Staff Report

Floodplain Development Review

File: FP-02-20

Subject: Review of Floodplain Development Permit Application FP-02-20, Albany Wastewater Treatment Plant.

Figure 1

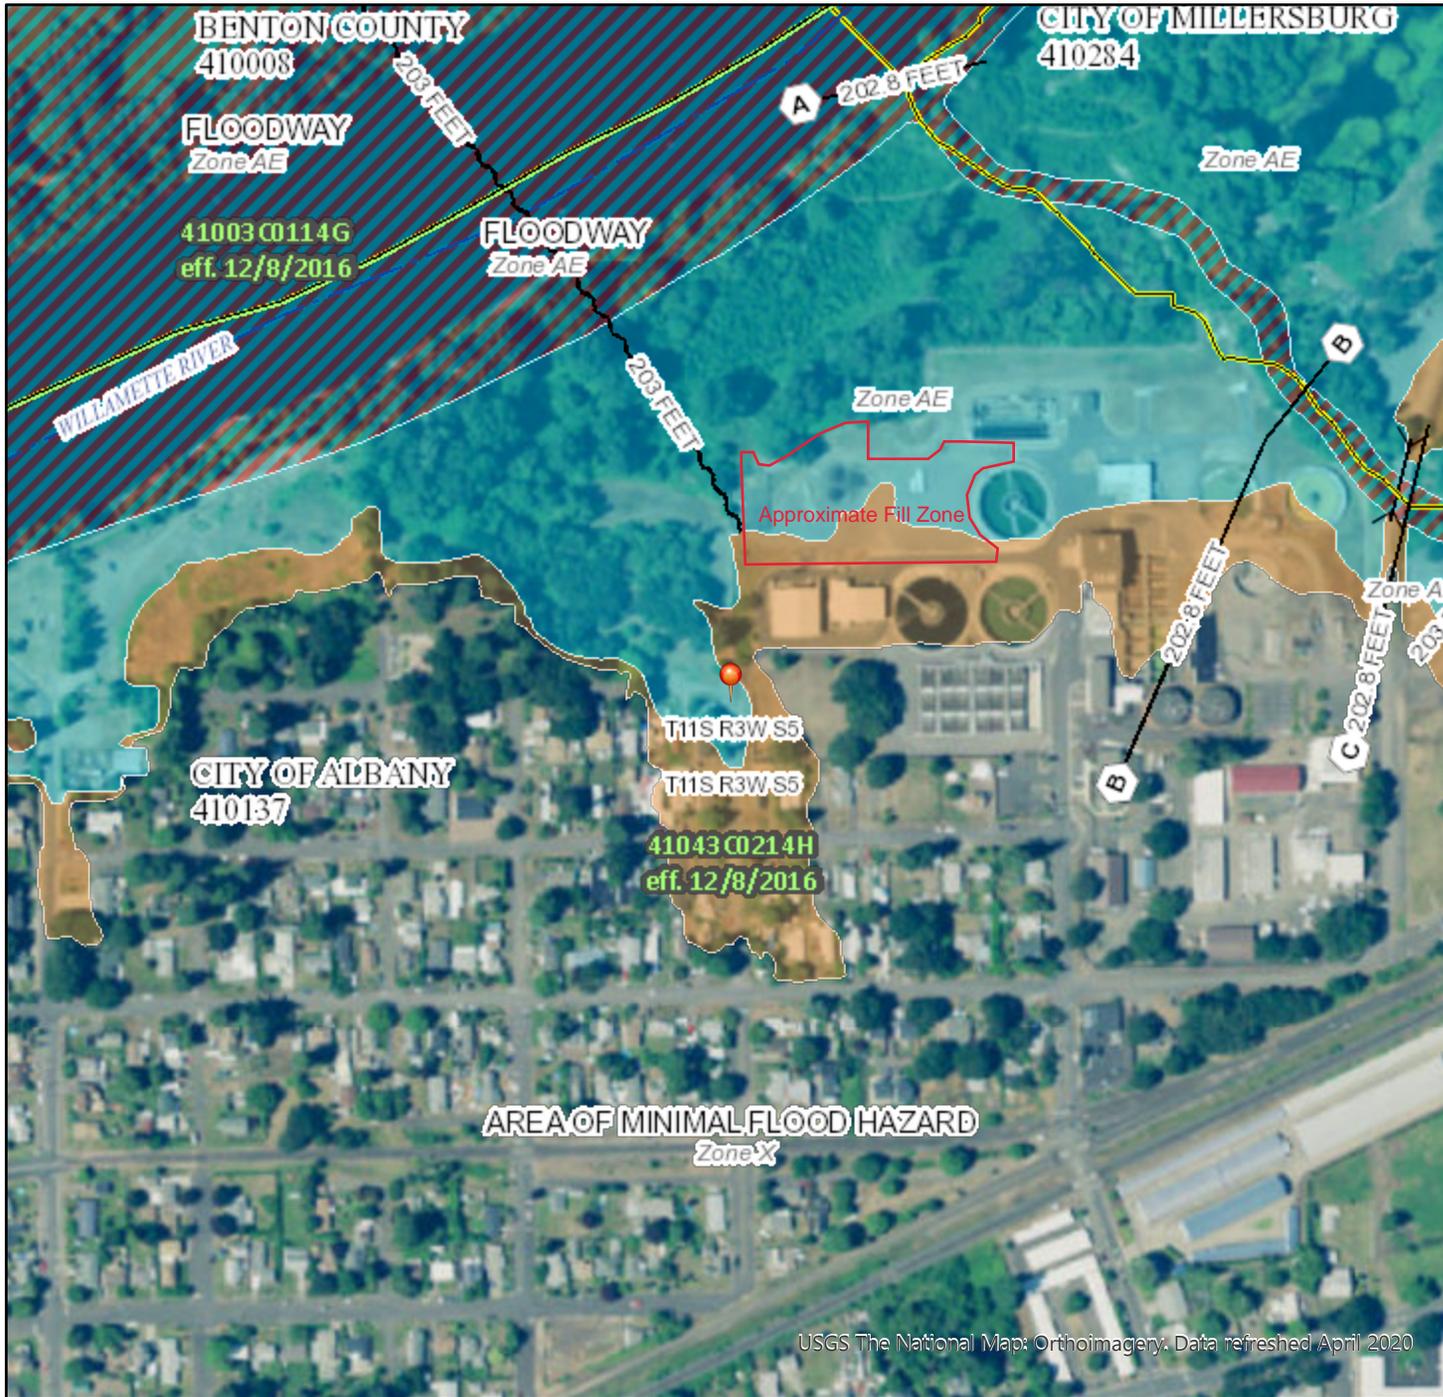
WEST Consultants has completed a review of the Floodplain Development Permit Application no. FP-02-20. The subject property is the City of Albany wastewater treatment plant. The treatment plant address on the application is listed as 554 Columbus Street NE; however, the plant is generally located north of Front Ave NE, between NE Columbus Street and Waverly Drive NE. Based on the effective FEMA Flood Insurance Study (FIRM 41043C0214H, dated Dec 8, 2016), the subject property is located within a FEMA Zone AE Special Flood Hazard Area, in the right overbank of the floodplain of the Willamette River. A regulatory floodway has been defined for the area and a portion of the subject property is located within the floodway.

The applicant proposes placement of fill in a location to be later used as a composting facility. The fill will be placed over an approximate area of 1.2 acres, which is located within the floodplain, but outside the floodway. The approximate fill area is shown in Figure 1.

The City of Albany Development Code allows fill within the floodway provided it does not reduce the flood carrying capacity of existing watercourses. Preliminary grading and fill plans provided by the applicant's engineer (Kennedy Jenks) show that the fill will be placed outside the floodway; therefore, flood carrying capacity is not affected. Provisions 6.100 and 6.111 require that the proposed plans be stamped by a licensed engineer. Since the provided plans are considered preliminary, they are not stamped. Provided that the final stamped plans, to be submitted at a future date, remain consistent with the preliminary plans and the proposed fill remains outside of the regulatory floodway, provisions 6.100 and 6.111 of the City of Albany Development Code are satisfied. The Floodplain Permit Review Checklist is shown in Appendix A. Supporting documentation is included in Appendix B.

FILE NAME
1976019.00-C-2.dwg
 JOB NO.
1976019.00
 DATE
APRIL 2020
 SHEET OF
C-2

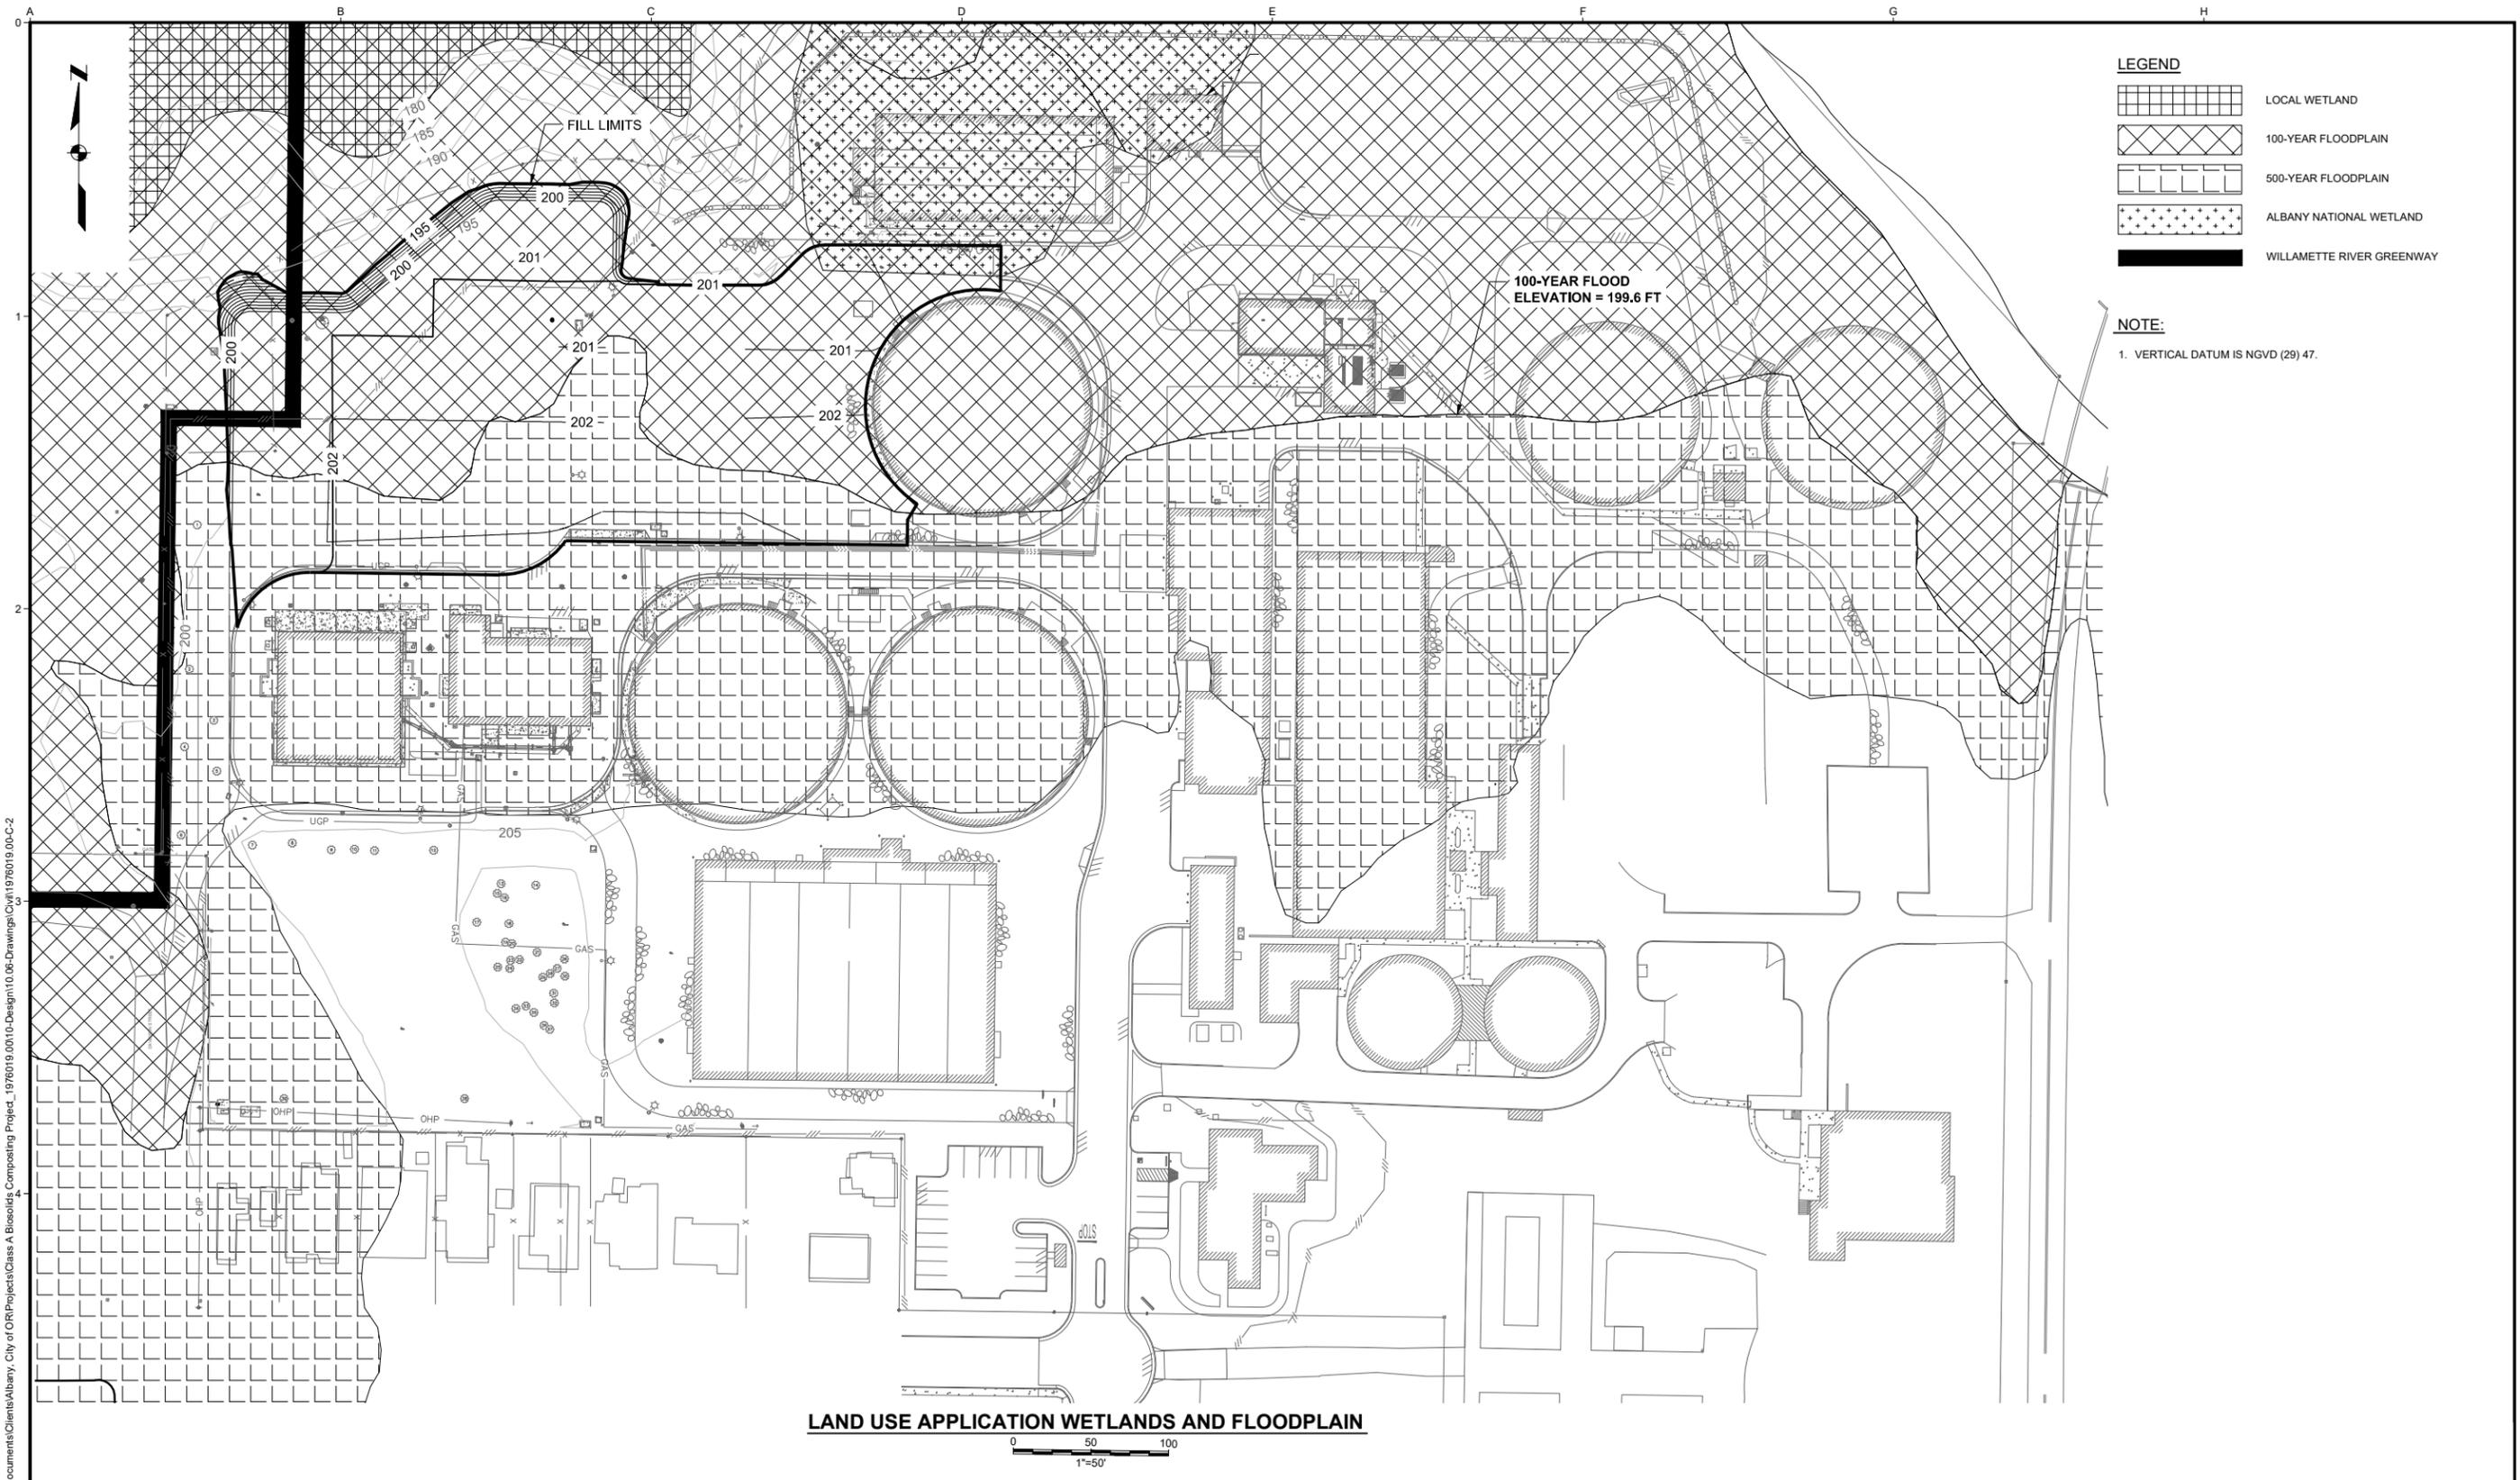
- 1.5 The Grading Plan (Attachment F, Sheet C-1) shows the area impacted is 86,400 square feet in size. There will be 3,200 cubic yards of native material cut and 8,800 cubic yards of material filled, which will result in 5,600 net cubic yards of fill on-site. The grading plan shows the fill will bring the existing ground elevation up by approximately six feet at its highest to an elevation of 204.38 feet (NAVD 1988). The FIS and FIRM show the Base Flood Elevation (BFE) at the site is 203 feet (NAVD 1988). Therefore, the impacted area is proposed to be raised above the BFE.

- 3.1 A 54-inch trunk sewer main runs through the area of proposed fill. The fill will add up to six feet at the highest point of cover over this main. The City Engineer has approved the additional fill over the sewer main.
- 3.2 The applicant's submittal indicates a manhole will be raised to the new elevation to accommodate the change in depth over the existing sewer main.

The proposed land use application grading and fill plan (sheet C-1) shown on the notice file FP-02-20 includes ± 4 feet of fill over the same sanitary sewer trunk main just downstream of The Banks [project]. We have no objections to this application but think it is important to draw attention to the additional fill for the record. We are confident that City staff will take into consideration the proposed fill over the sewer main with their staff decision and include conditions that will ensure that any additional fill will be completed in a way that protects the service life, operation and maintenance of this critical City infrastructure.”

The proposed Land Use Application Grading and Fill Plan (Sheet C-1) shown in the Notice File FP-02-20 includes ±4-feet of fill over the same sanitary sewer trunk main just downstream of The Banks. We have no objections to this application but think it is important to draw attention to the additional fill for the record. We are confident that City staff will take into consideration the proposed fill over the sewer main with their staff decision and include conditions that will ensure that any additional fill will be completed in a way that protects the service life, operation, and maintenance of this critical City infrastructure.

Response: Because the sewer trunk main lies within City property (Albany Wastewater Treatment Plant), no public utility easement is needed over the main to provide access to and space for maintenance/repair of the trunk main. Typically, easements for sewers are wide enough to allow for one horizontal foot on each side of the main for each foot of depth. For a 25-foot deep sewer, this would result in a 50-foot wide easement. Such an easement would likely significantly affect development on private property, and the impact on private property of potential repair of the main would also be significant. Because the trunk sewers near the WWTP are typically among the deepest in the City, the Treatment Plant is designed to accommodate such depths and any issues with maintenance and repair do not impact private property owners.

- 3.4 The City Engineer has determined that the additional fill over the existing public sanitary sewer main will not be detrimental to the anticipated service life, operation, and maintenance of the existing utility.
- 3.5 This criterion is met without conditions.
